# **Evaluation of Weakly Informed Priors for FLEX Data**

**Prepared for the  
Division of Risk Analysis  
Office of Nuclear Regulatory Research  
U.S. Nuclear Regulatory Commission  
NRC Agreement Number 31310019N0006  
Task Order Number 31310019F0022**

On behalf of the U.S. Nuclear Regulatory Commission, Idaho National Laboratory (INL) reviewed the development and use of weakly informed prior (WIP) probability distributions to obtain industry-wide failure probability and rate distributions for portable FLEX equipment, as documented in the Pressurized Water Reactor Owner's Group (PWROG) draft report, *FLEX Equipment Data Collection and Analysis* (PWROG-18043-P Revision 0) by M.M. Degonish. The review includes a description of the methods used by the PWROG analysts. It also includes an implementation of those methods for comparison purposes, as well as an implementation of two constrained noninformative (CN) distributions for further WIP comparisons.

Due to these issues, INL reviewers believe the WIP distributions presented in the report to be deficient for use in risk assessments at the present time.

Figure 1. Posterior distribution 5<sup>th</sup> percentiles, mean values, and 95<sup>th</sup> percentiles for the probability of failure to start for components with WIP distributions.

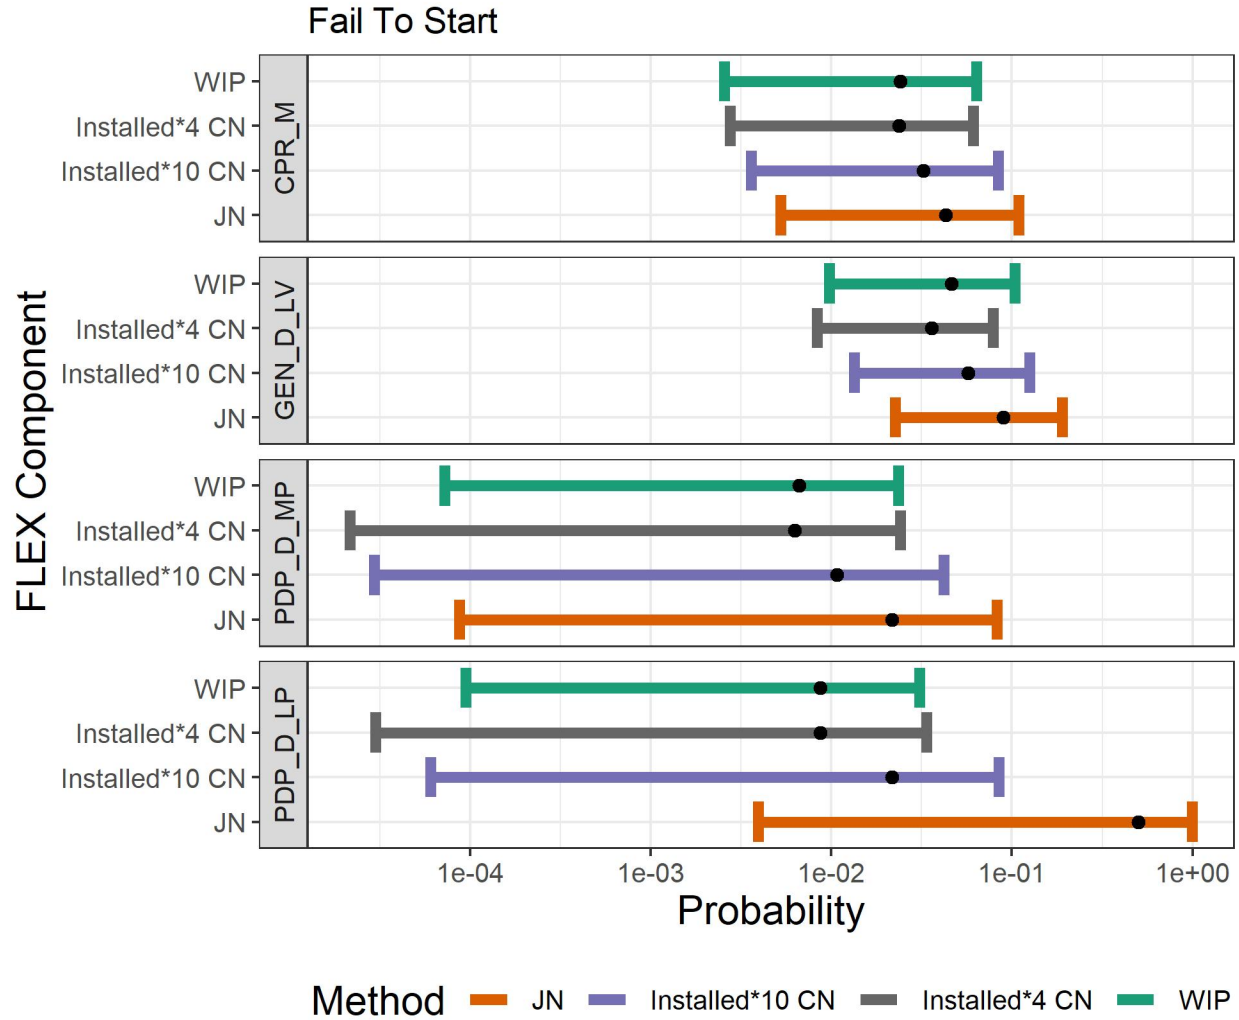
- The means and bounds generally have a smaller spread for the components at the top of the figures, and a larger spread for those at the bottom, reflecting the impact of more operational experience. The narrowest bands, however, are for the components that had failures. In Figure 1, the top component had one failure and the second had two. The other components had no failures. In Figure 2, no components had failures, except for the one in the second band (PDP\_M\_MP) that had one failure.

- In virtually every case, the JN method has the highest mean and the highest 95<sup>th</sup> percentile. Among the methods considered, it is the only one not influenced by the industry installed equipment mean values.

- The two CN distributions have identical spreads for their bounds because they have the same alpha parameter for FTR rates, as well as similar alpha parameters for FTS probabilities. As expected, the Installed\*10\_CN bounds and mean are to the right (higher probabilities and rates) than the Installed\*4\_CN values.

Figure 2. Posterior distribution 5th percentiles, mean values, and 95th percentiles for the rate of failure to run for components with WIP distributions.

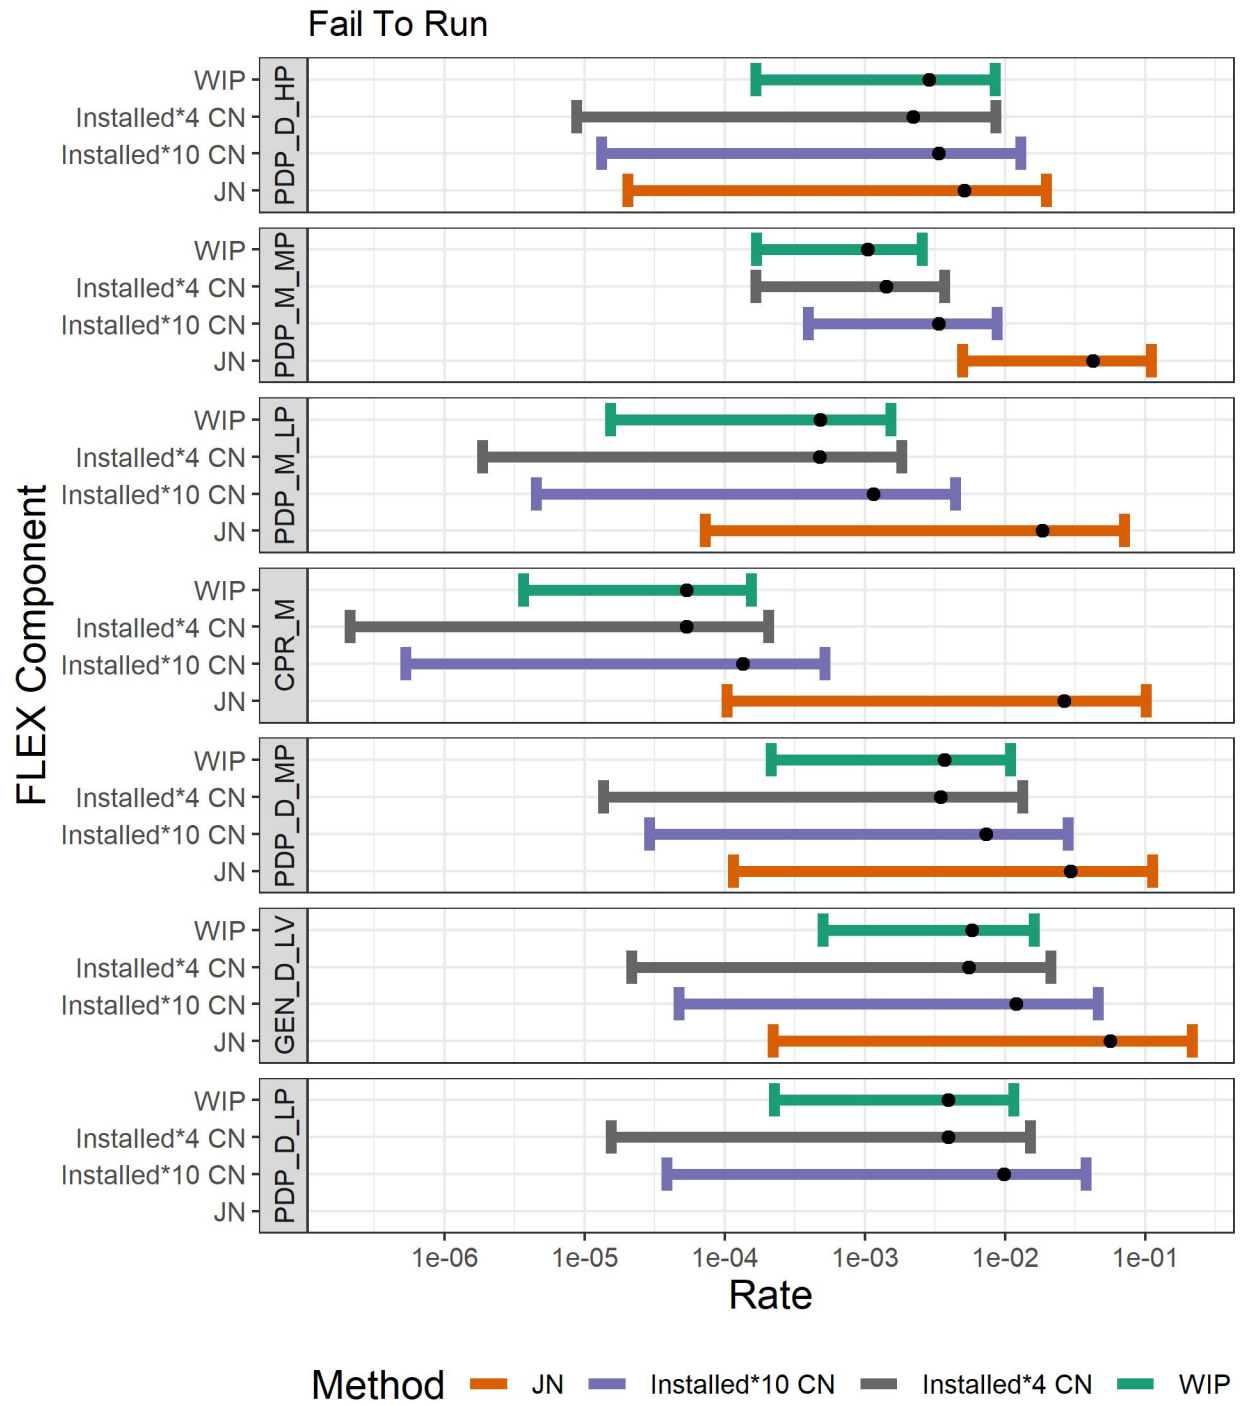
Two features in Figure 2 deserve further explanation. First, there is no JN plot for the component at the bottom of the figure (PDP\_D\_LP). The diesel-driven positive displacement pumps with low

pressure/high flow rates had absolutely no data (no operating hours, no demands, no failures), though they are listed in the PWROG study. For the JN method for gamma distributions, the data mean is  $(f+0.5)/T$ , so run time must be greater than 0 to evaluate the posterior mean.

The second anomaly in Figure 2 is the lower WIP and CN distribution bands for motor-driven compressors (the middle set of bands in this plot). The values are low because the FTR industry value for installed compressors is an order of magnitude lower than the other values used in the FLEX component study.

- The WIP distribution posterior mean values are close to the Installed\*4\_CN posterior mean values. Both distributions have the same prior mean.
- In every case in Figure 2 (FTR distributions), the WIP posterior distributions appear narrower than the other distributions. This is not so apparent in Figure 1 (FTS), which reflects the changes that occurred when the algorithm for finding beta distributions with specified means and variances was corrected. One effect of the change was that the prior alpha parameters became much lower. The change widens the prior distribution, thus somewhat widening the posterior FTS distributions, as well.

Figure C-1. Posterior WIP and JN mean values for the probability of a component's failure to start as a function of the number of demands.

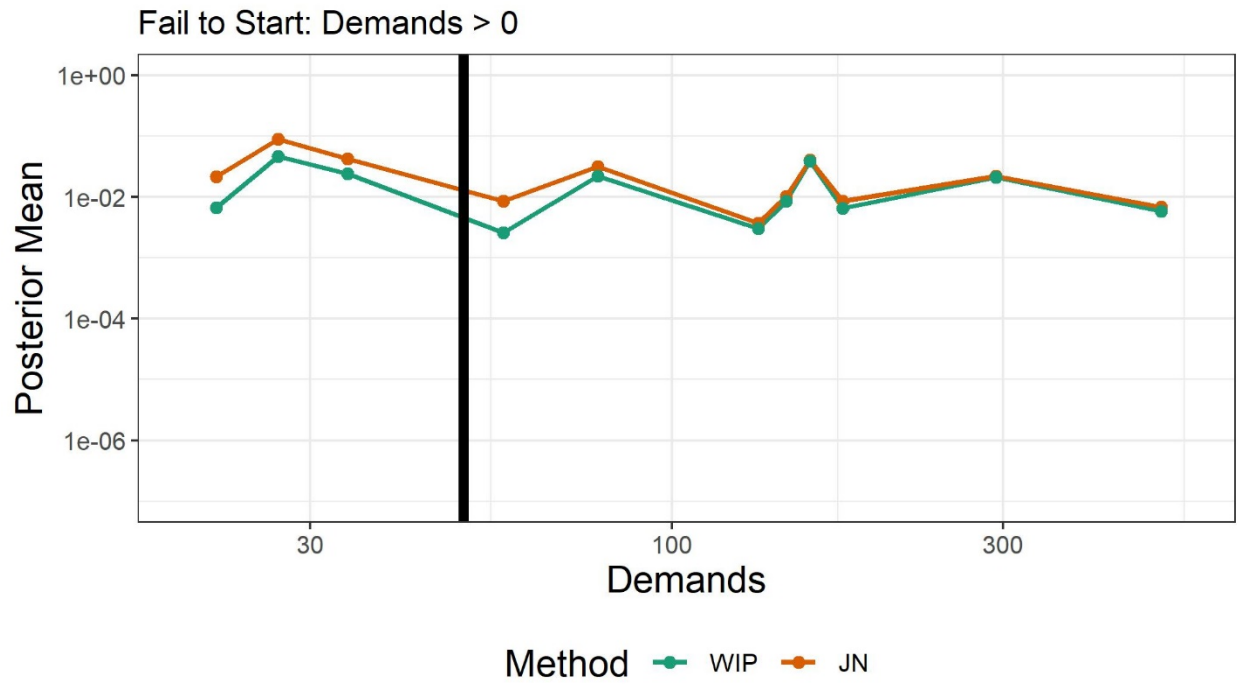
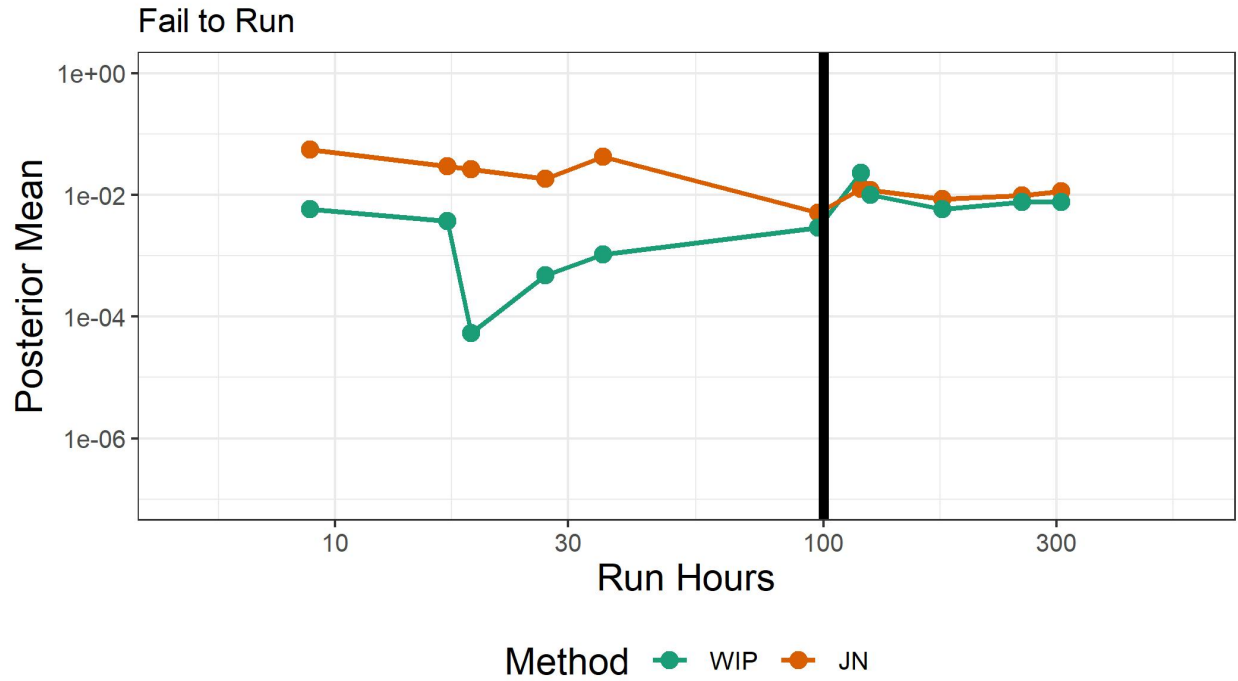
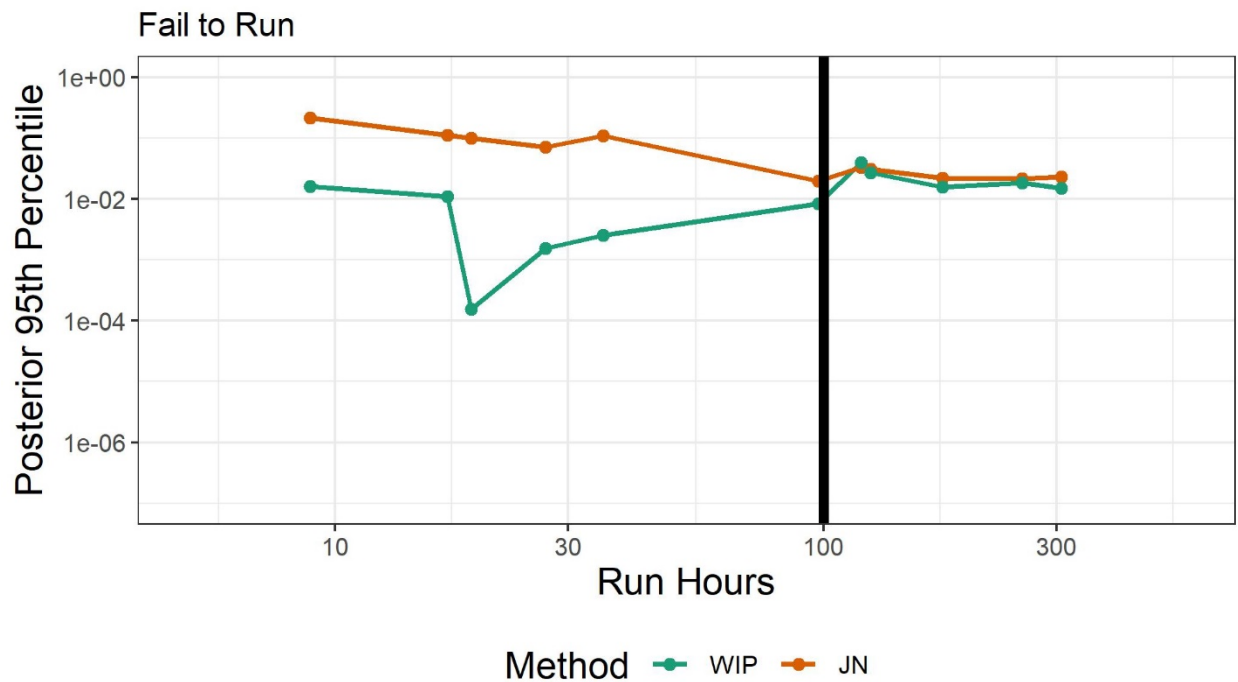
The JN distribution uses only the FLEX data, whereas the WIP distributions start with data for installed components that have been used for years in the NPP industry. The mean values for the industry data are thus typically lower than those that come from the FLEX data (even though those mean values are increased by a factor of 4). The dip in Figures C-3 and C-4 in the PWROG (WIP) data are caused by a 1.35E-5 industry value for motor-driven air compressors. It is unsurprising that lowering the cutoff values increases the estimated mean and standard deviation. Sometimes, the difference is greater than an order of magnitude. This situation holds true for both FTS and FTR.

The 95<sup>th</sup> percentile plots show a similar pattern, with the JN values considerably higher than the WIP percentiles on the left. Even if the mean values were the same, the JN 95<sup>th</sup> percentile would exceed the WIP percentile any time the posterior JN  $\alpha$  was less than the posterior WIP  $\alpha$  parameter. Thus, decreasing the cutoff value for WIP increases the uncertainty estimates for the affected components.

Figure E-1. Portable diesel-driven centrifugal pump (high pressure, low flow rate)—FTR.

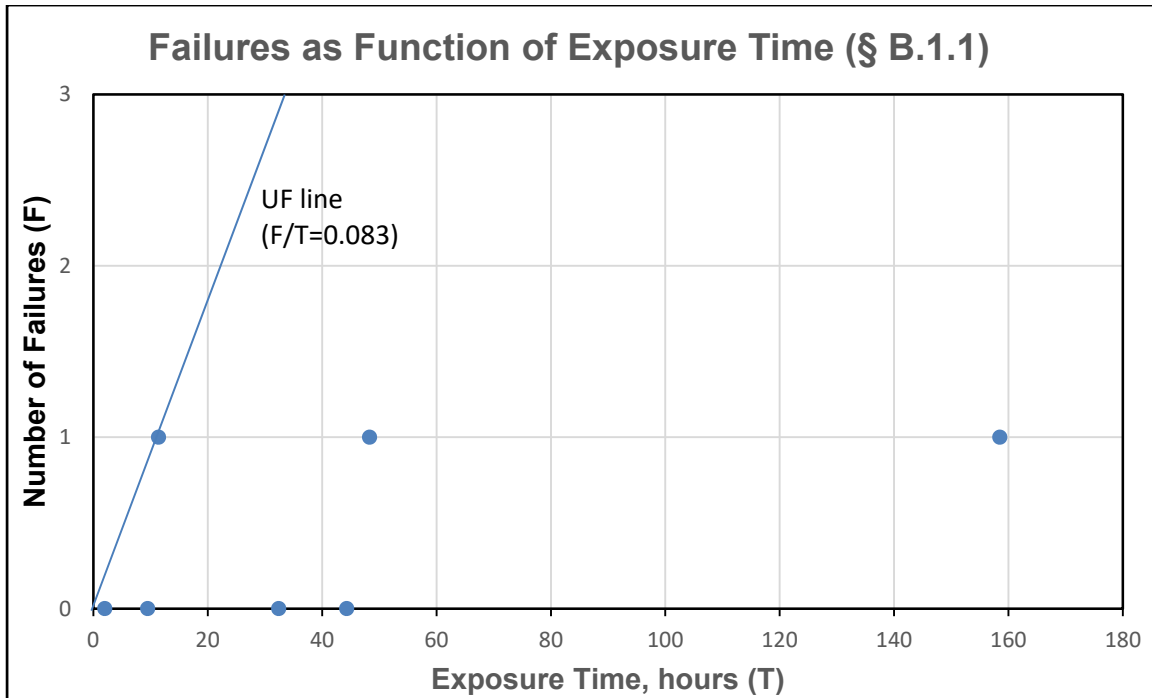
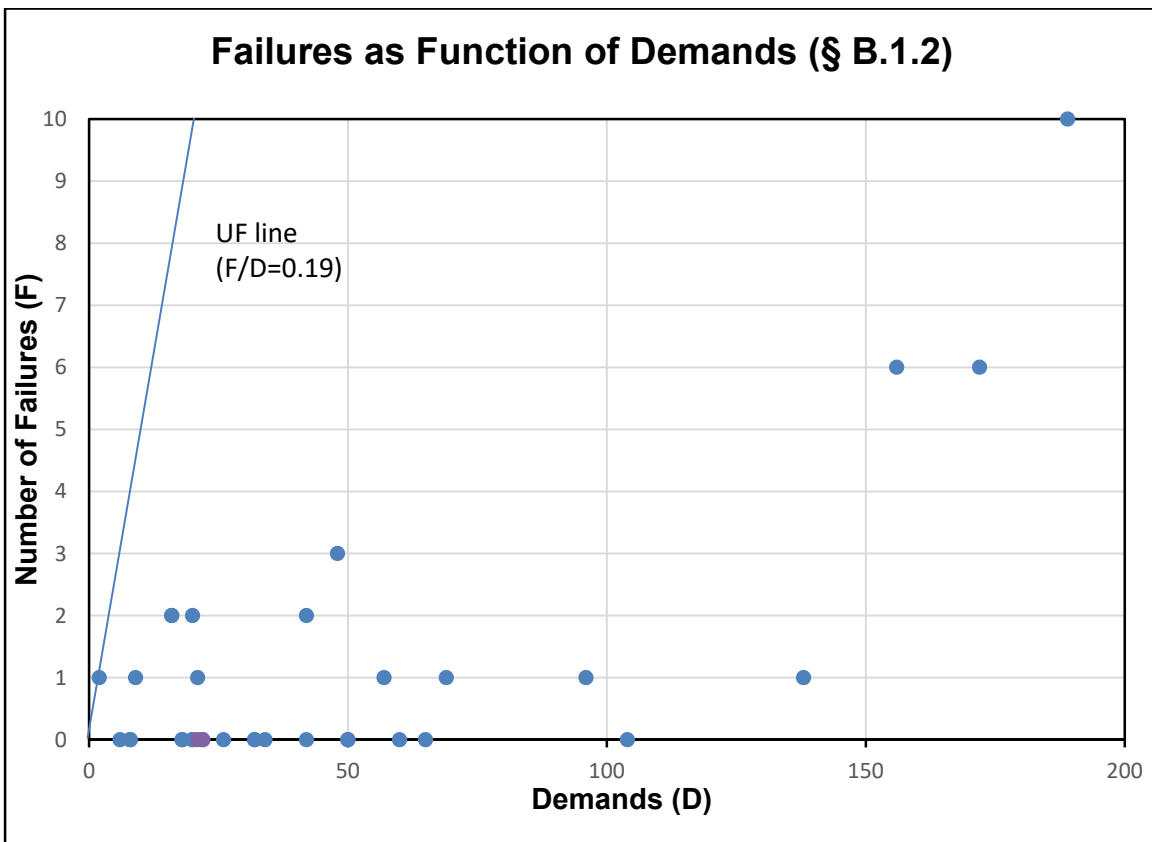
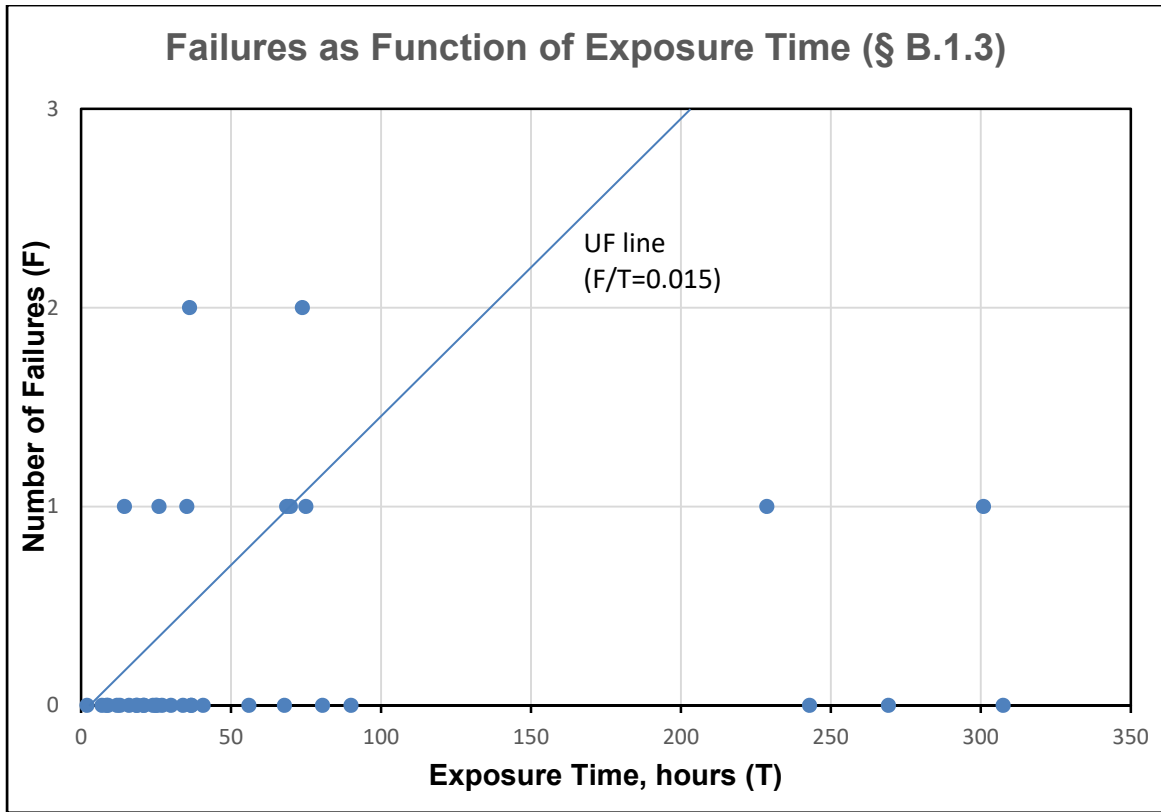
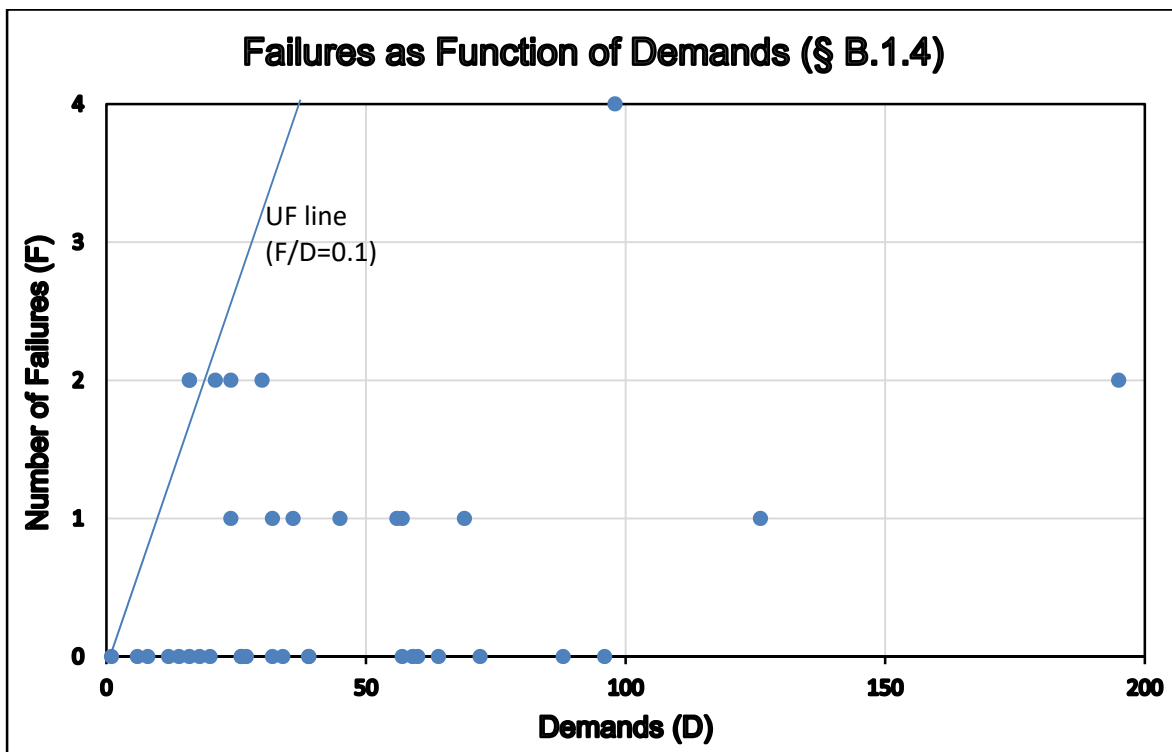
In the first two plots, only one point exceeds the UF, and it has only one failure. The demands or exposure time are low. The third plot has five points to the left of the UF. The last has just one observed point but it is actually two sites, each with two failures and the same small number of demands.

Figures E-1 through E-4 show a different type of potential outlier. The aspect of the data that most stands out to the casual observer is the great disparity in exposure times and the numbers of demands from one facility to another. Some sites have data from as early as 2008, though guidance for implementing the FLEX program was not issued until 2012, and was modified as recently as December 2016. Inclusion of data from before the implementation of the FLEX program for these sites may be the primary cause of this disparity. Including these data makes the FLEX data unbalanced. The components at those sites have a much bigger influence on the outcome than do other components. If they are atypical in any way, the datasets will be biased. Excluding old data (which would apply only to the site itself, not the industry as a whole) could produce significant changes in the PWROG FLEX uncertainty distributions.
